Planning for Exterior Work on the First Parish Church

Portland, Maine

Using Photographs as Project Documentation

A Preliminary Survey of the Building

Fig. 1. Deterioration of Roofing and Flashing.

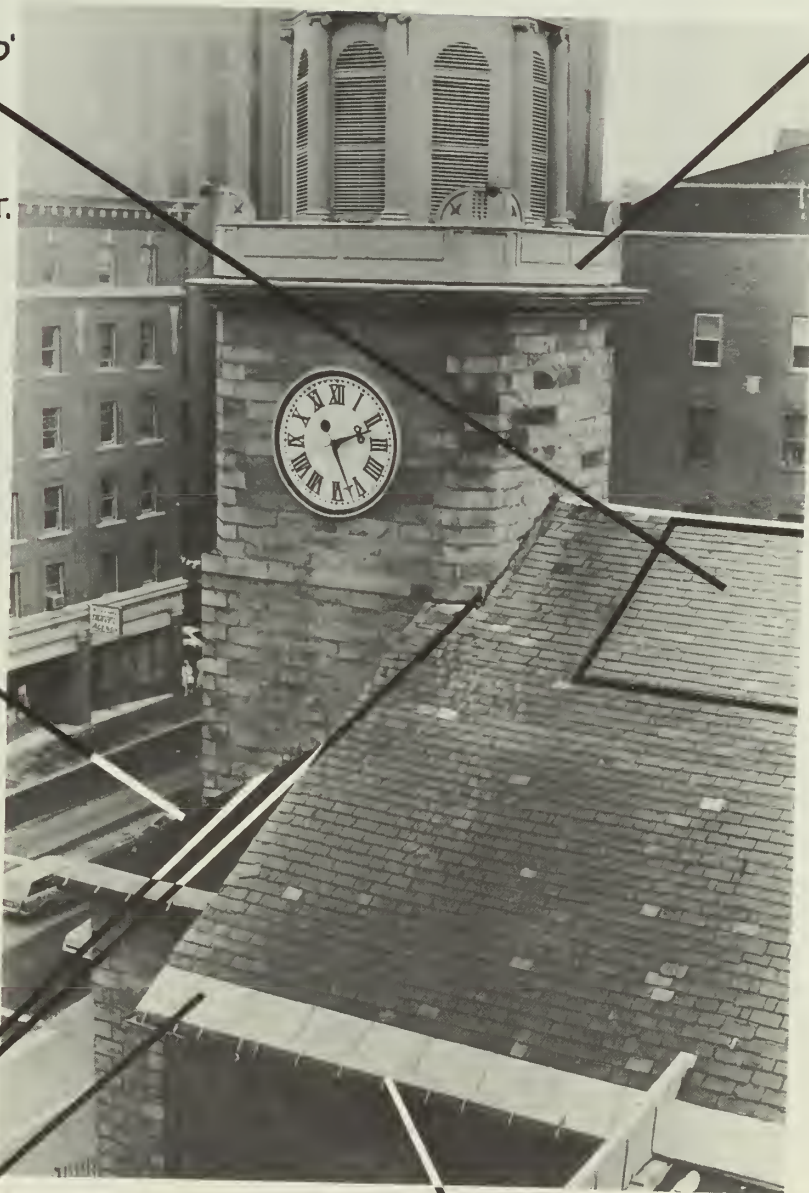
The existing slate roof has undergone numerous repairs over the years and therefore includes several different colors and sizes of slate. Most repairs have been limited to replacement of individual slates, except near the tower where an approximately 15' x 30' section was replaced with green slate (Fig. 1:a) in what was evidently an early, rather sizeable repair job on the main roof (see also Fig. C). Comparison of what we assume is an original slate with other slate samples indicates that the original slate was Welsh purple. We would estimate that only 20–30% of the existing slate can be re-used; the remaining 70–80% will have to be new slate. Obviously, when laying old and new slate side by side, a close color and size match are desirable. New slate will also be required for the two small hipped roof surfaces on either side of the tower, at present covered with black asphalt shingles (Fig. 1:b). Some holes, leaks and previous patching attempts are evident in the roof sheathing when viewed from the attic space. We estimate that 10–15% of the existing roof sheathing will have to be removed and replaced. Other areas of concern are the flashing and counter-flashing. Completely new flashing and counter-flashing will be required at the rear chimney and wherever any roof surface abuts the masonry tower (Fig. 1:c). The existing eave flashing appears to be in good condition (Fig. 1:d). A related flashing item is the re-hanging of several sections of gutter in order to facilitate better drainage (Fig. 1:e). A new metal ridge roll for the main roof and metal hip rolls for the two small hip roofs adjacent to the tower would also be required. Replacement of the existing attic ventilation system at the main roof ridge is also advisable.¹ Inspection of the existing copper roof at the base of the steeple (Fig. 1:f) for any cracks in the seams or joints is recommended. Several water-stained areas were noted in the sheathing beneath this surface which may indicate a leak. Re-soldering of suspect seams should eliminate any current water penetration (see Part 2 specifications, Slate Roofing 06500 and Flashing 07600).

f. INSPECT COPPER ROOF
AT BASE OF STEEPLE

a. APPROXIMATE 15'x30'
PATCH OF INAPPRO-
PRIATE GREEN
SLATE REQUIRING
TOTAL REPLACEMENT.
PATCH IS VISIBLE
IN 1865 PHOTO.

b. HIP ROOF SURFACES
COVERED IN INAP-
PROPRIATE BLACK
ASPHALT SHINGLES
REQUIRING TOTAL
REPLACEMENT

c. NEW FLASHING AND
COUNTERFLASHING
NECESSARY WHERE
ROOF SURFACES
ABUT MASONRY
TOWER

d. EXISTING EAVE FLASHING
IN GOOD CONDITION

e. SECTIONS OF GUTTER
NEED REHANGING

in view of the building's early roof repairs, another approach was selected in conjunction with the roofing contractor, Mr. C. Gordon LaRose, Portland Roofing Co., South Portland, Maine: a slate comb roof on the main roof and slate fantail hips on the two small roofs adjacent to the tower (see Part 2 specifications, Slate Roofing 06500).

Fig. 3 Cornice Deterioration at the Urn Level of the Steeple.

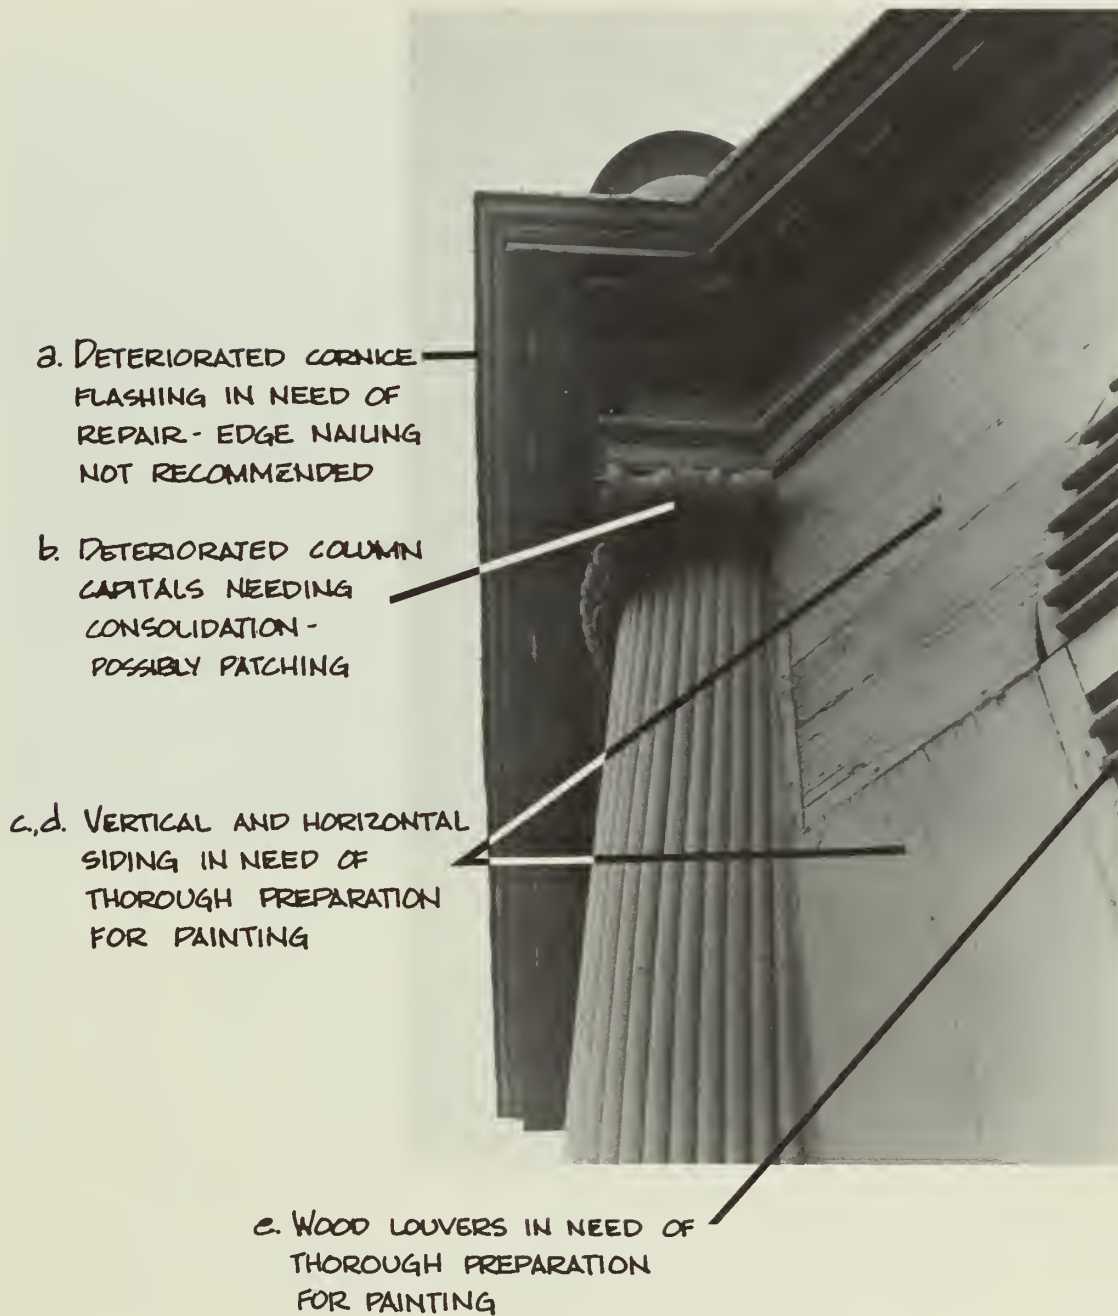
The cornice flashing, edge-nailed into the crown moulding (Fig. 3:a) is no longer serving its intended function of throwing water away from the cornice below. Instead, the many open nail holes provide an avenue for moisture penetration. Therefore, it is strongly recommended that all existing cornice flashing at this level be replaced and that all new flashing be detailed in such a manner as to avoid edge-nailing. Additional deterioration, including some large holes, is evident at several locations in the cornice soffit and should be repaired. Many of the Ionic column capitals also show weathering and deterioration at their upper surfaces (Fig. 3:b). Where possible, these areas should be consolidated and patched; the worst areas may require piecing-in of new wood. The vertical (Fig. 3:c) and horizontal sheathing (Fig. 3:d) needs a thorough scraping in preparation for painting, in addition to localized patching or caulking of open areas in the wood. The wood louvers (Fig. 3:e) require similar preparation prior to painting (see Part 2 specifications, Rough Carpentry 06100 and Flashing 07600).
